**RC1: 'Comment on egusphere-2024-3566', Anonymous Referee #1, 03 Jan 2025 reply**

This manuscript introduces the Flying Laboratory (FLab), a hexacopter equipped with six instruments to measure aerosol properties, trace gases, and meteorological parameters in real time with high temporal resolution. Designed to monitor urban and semi-urban environments near aerosol sources, FLab bridges the gap between ground-based and aircraft profiling. During field experiments, it performed hourly vertical profiling flights up to 300 m for eight hours, capturing lower convective boundary layer dynamics and afternoon vertical particle transport. This study details the FLab's technical setup, measurement characterization, and optimized flight patterns, showcasing its effectiveness in environmental monitoring. Overall, the manuscript is well-written. The results are interesting and valuable to the literature. I have some concerns especially for the measurement of wind and the impacts of flight speed on the pollutant measurement.

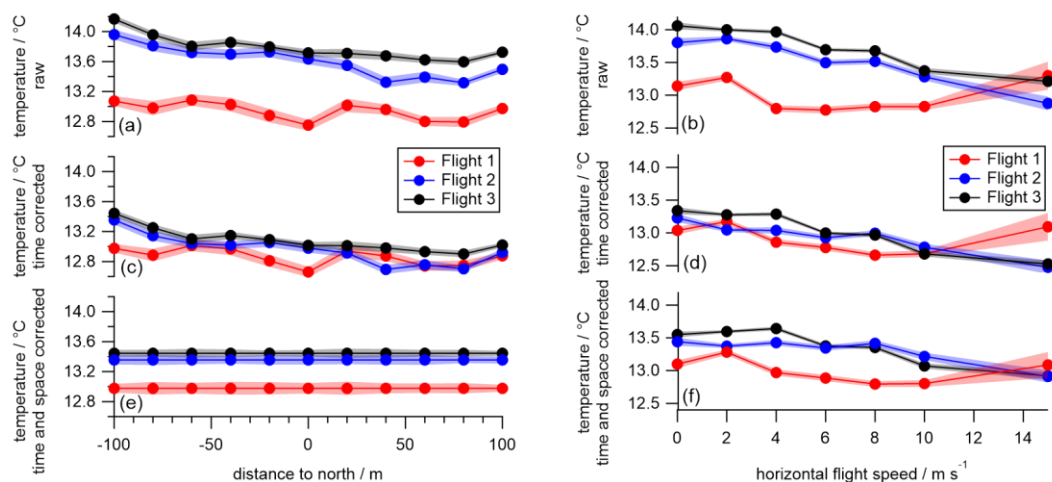
Lines 362-363: Rephrase or include an example to clarify the method of normalization used in the study.

→ We found that the term “normalization” in our original manuscript is misleading. We rephrased the paragraph that describes the temporal and spatial correction method in lines 395-411 for clarification:

Additionally, graphical clarification of the different steps of the correction method is shown in the newly added Fig. S7:

**Figure S6:** The CPC on FLab measures increased particle number concentrations from local plumes between the -30 m and 0 m-mark of the horizontal flight tracks during Flight 3.

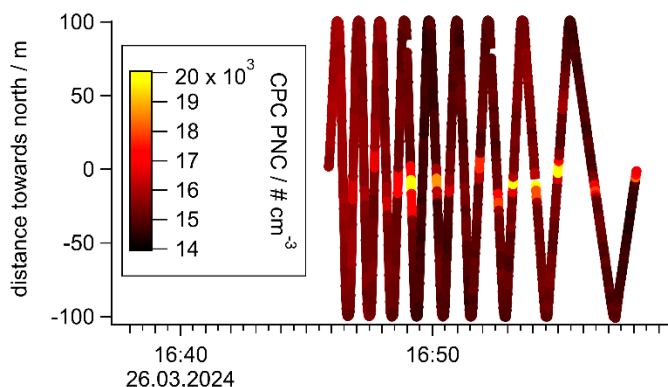
Lines 365-368: This could be due to the fact that the flights were conducted under relatively homogeneous conditions as the authors mentioned in line 277. However, how does the UAS perform in capturing pollutant concentration variations at different flight speeds over heterogeneous land surfaces?

→ The experiments in Sections 3.2 and 3.3 were designed to study how flight speed affects the measurement of variables. Therefore, it was important to perform these experiments under homogeneous conditions to minimize any influences that weren't measured at the reference station, MoLa. However, a single event during one of the flights (Flight 3) demonstrates that the instruments also perform well in capturing short-term changes of pollutant concentrations at different flight speeds. During flight 3 of the horizontal characterization measurements, the wind direction changed, and the MoLa exhaust plume polluted a short section of the flight track, as visible in the average in Fig. S5h and shown for the underlying 1-second data of the particle number concentration in the new Fig. S8 (see below). The UAS was operating at different horizontal flight velocities during the different legs of this flight, and the plume was clearly detected from the third leg on, independent of the flight velocity. Particle number concentration increased by more than 5000 particles  $\text{cm}^{-3}$  at various locations (depending on the slightly changing wind direction) between the -20 m and 0 m-mark during flight 3, illustrating FLab's capability to capture local inhomogeneities of pollutant concentrations independent of flight velocity.

For clarity, this figure was added to the supplement and an explanation was added in lines 391-394 of the manuscript:

"Figures S5h and S6 highlight the FLab's capability of resolving such small-scale inhomogeneities like the MoLa exhaust plume on a 1-second-time scale within a few tens of meters and independent of horizontal flight velocity, resulting in enhanced CPC PNC in the averaged horizontal flight tracks in this example."
